VENTURA UNIFIED SCHOOL DISTRICT

VETURA HIGH SCHOOL STADIUM UPGRADES AND SITE IMPROVEMENTS

ADDENDUM #03

Bid Addendum No. C

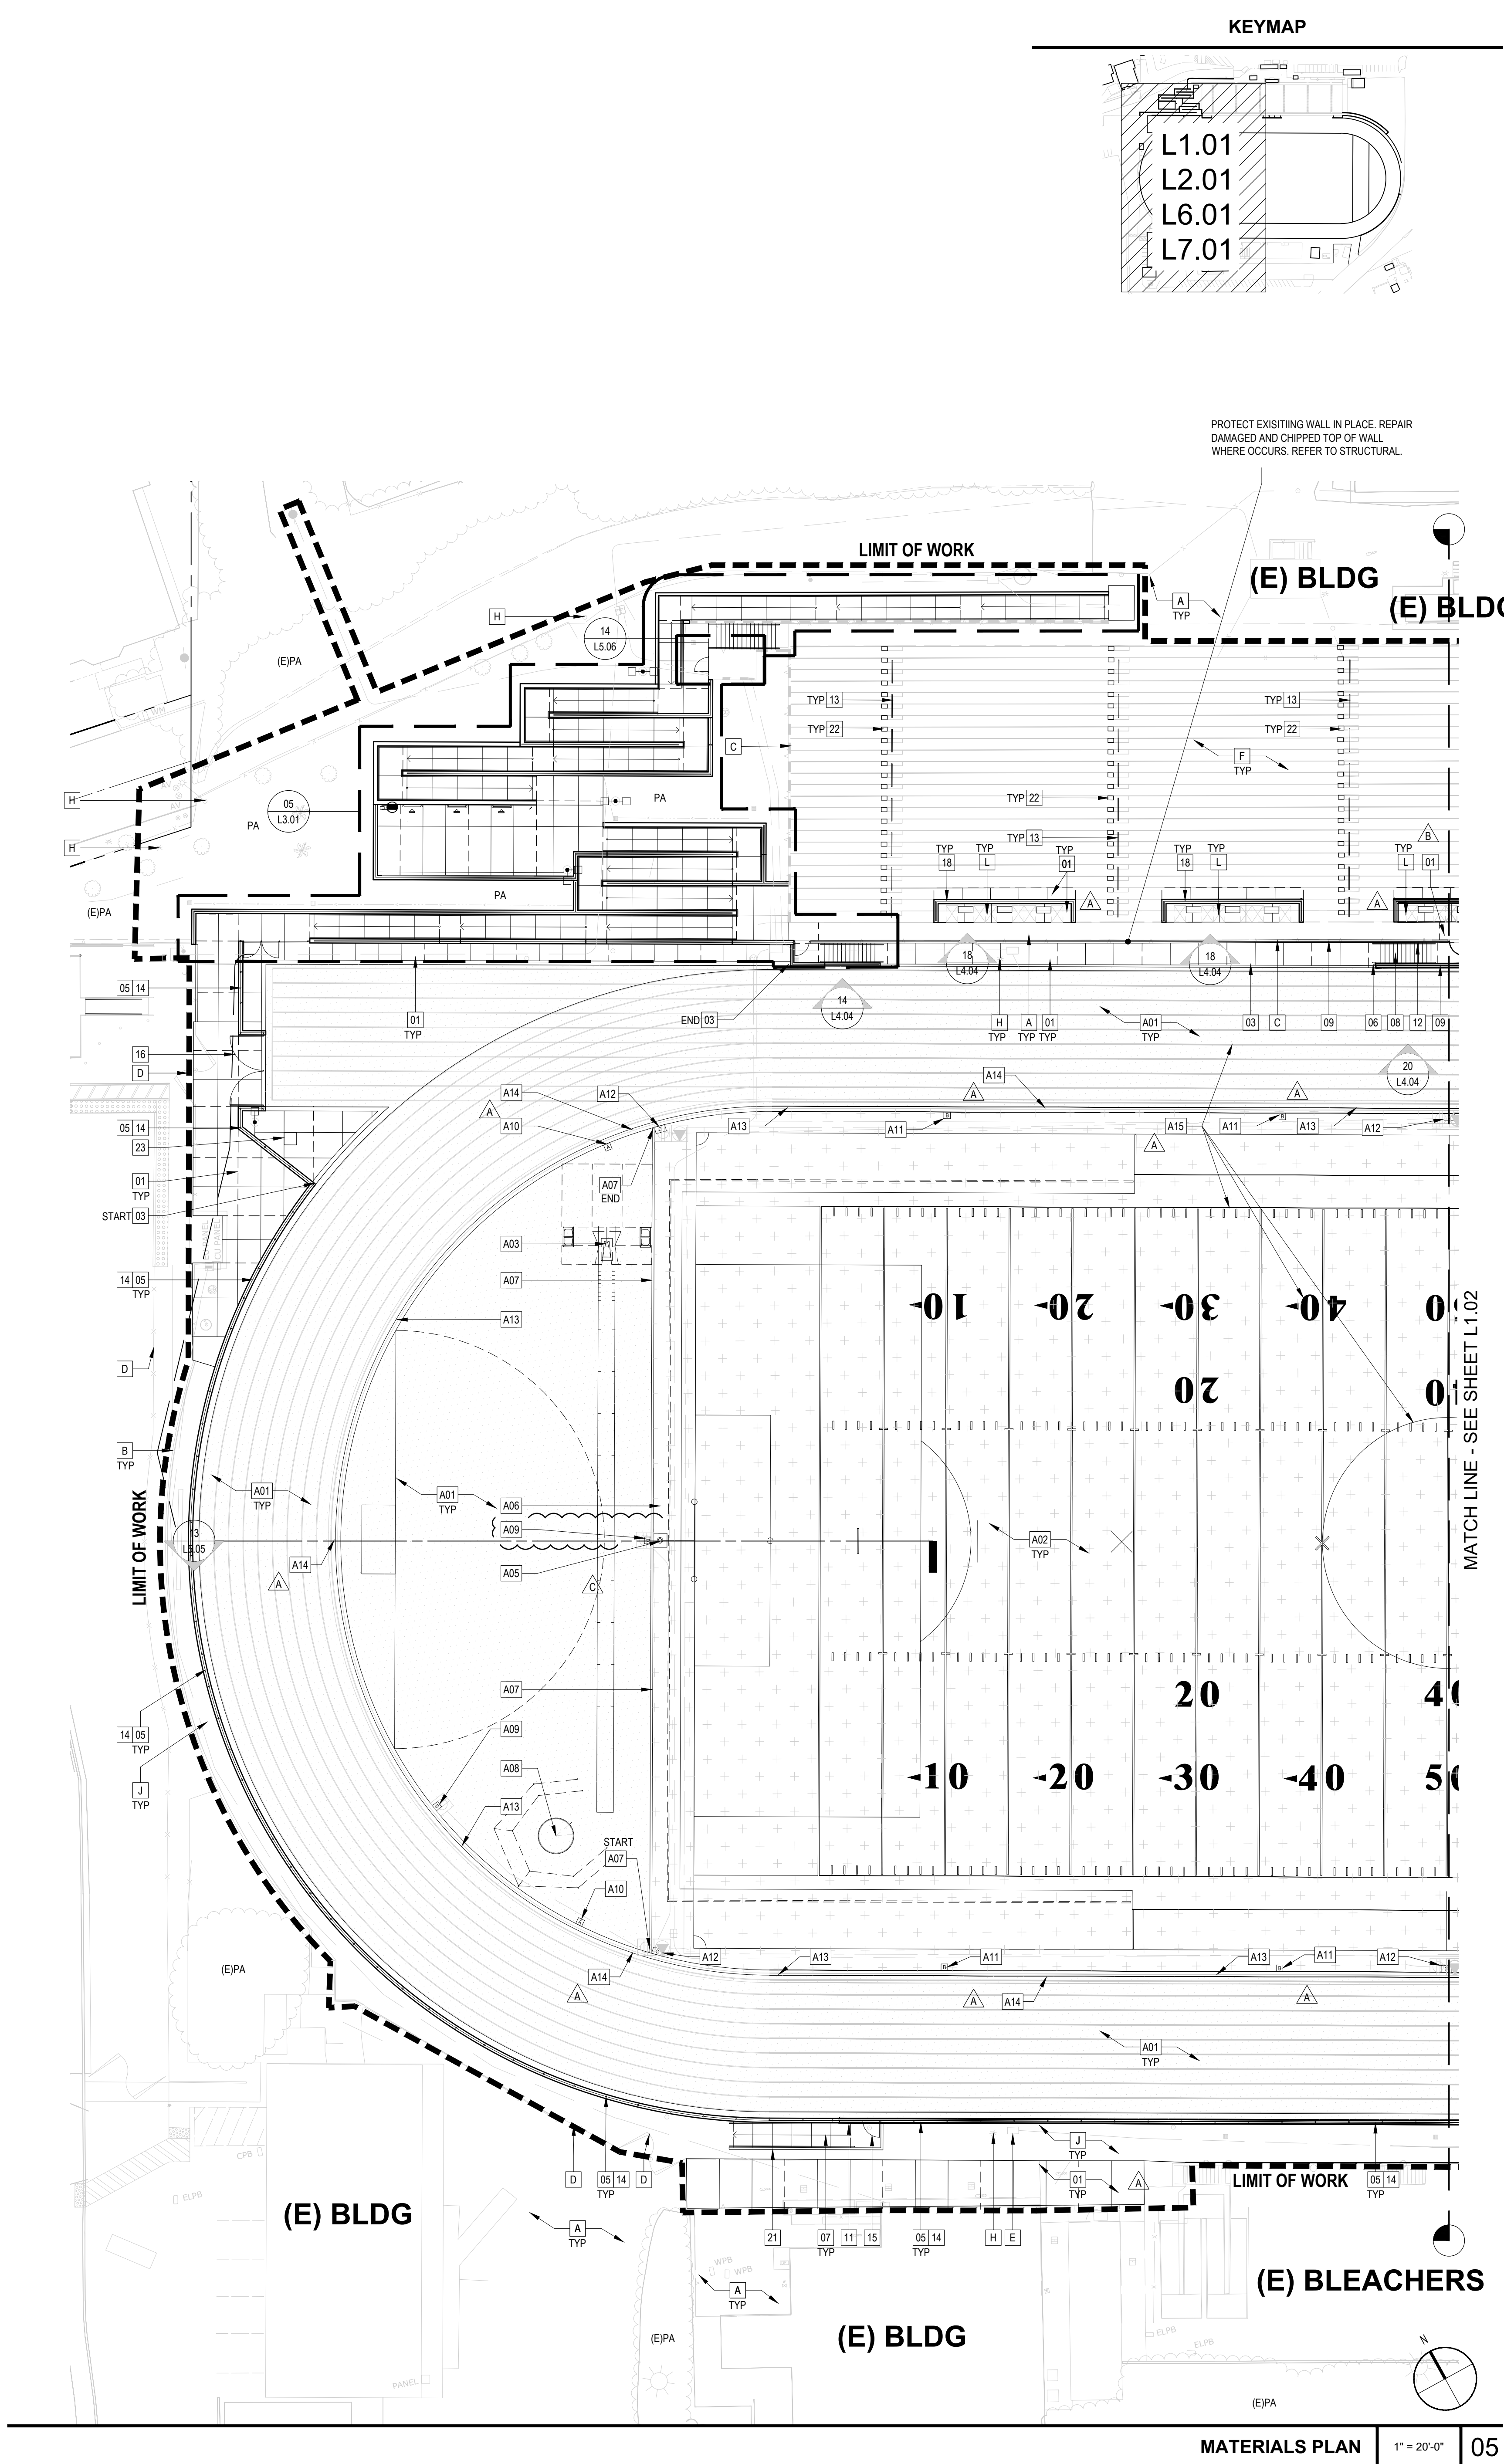
| Item No. 2 | L1.01 MATERIALS PLAN: <ul style="list-style-type: none">- Added callout A09 Utility Box at track behind football field goal post. |

MATERIALS PLAN

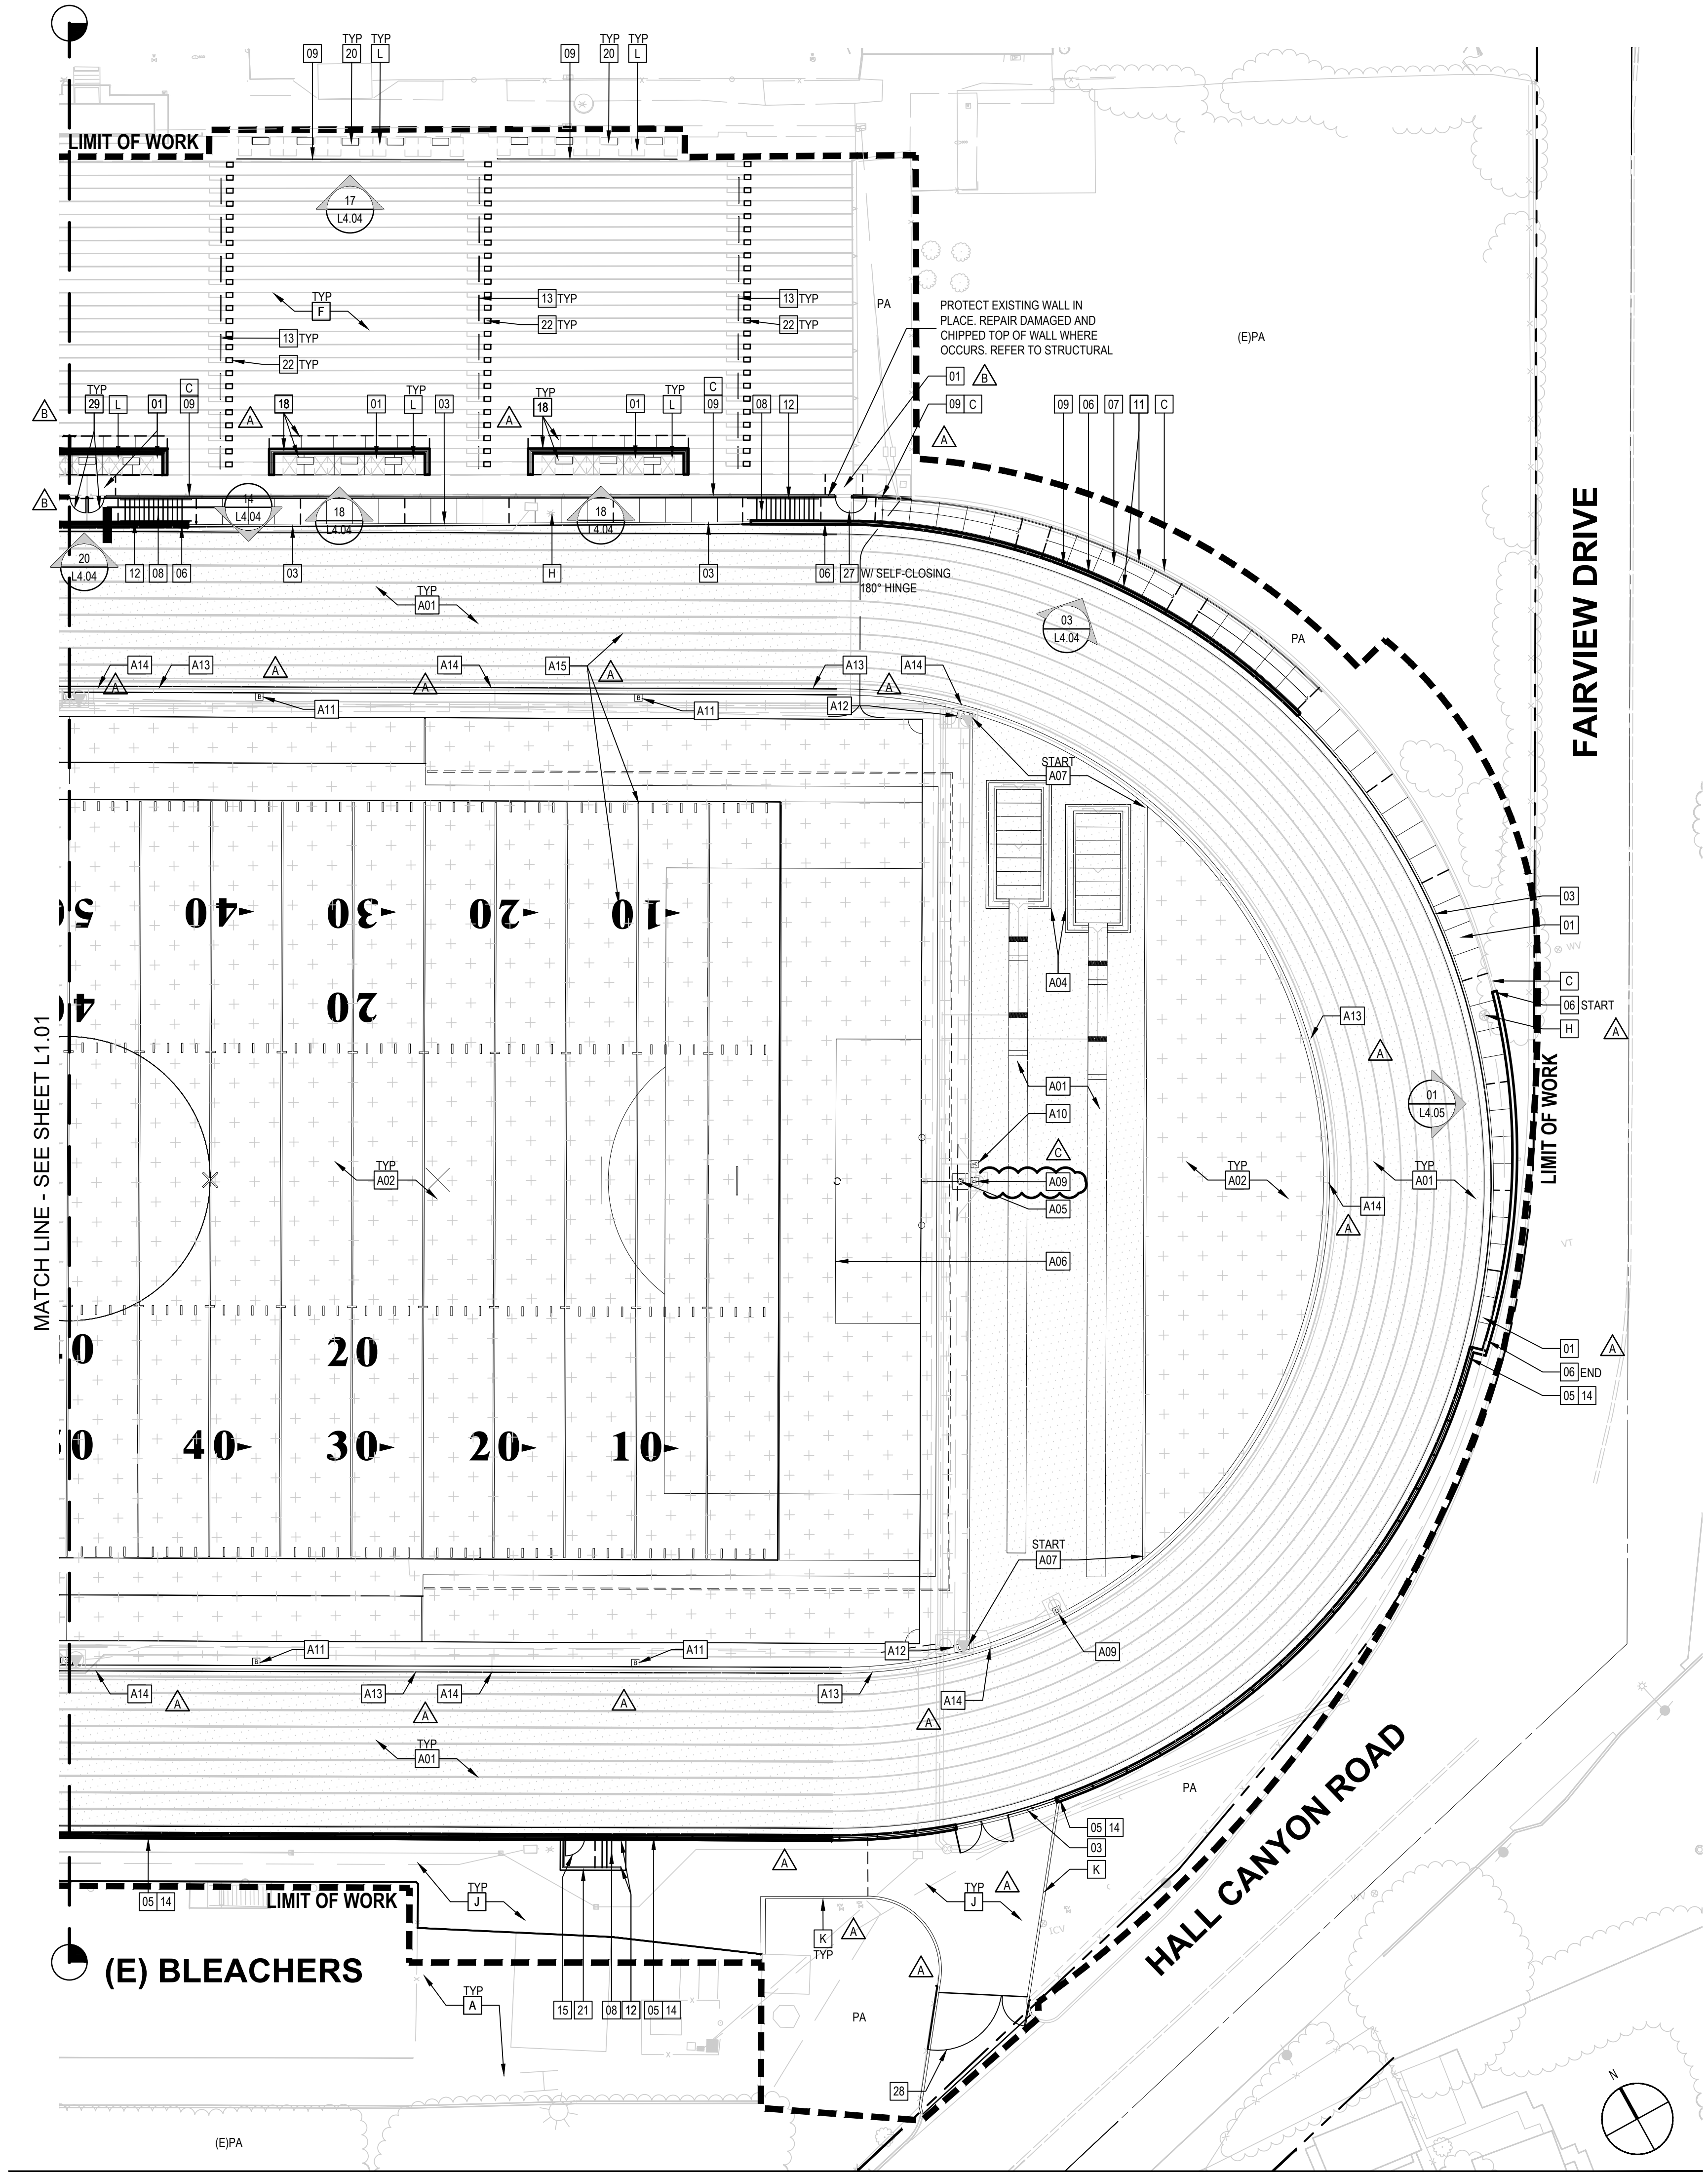
| Item No. 3 | L1.02 MATERIALS PLAN: <ul style="list-style-type: none">- Added callout A09 Utility Box at track behind football field goal post. |
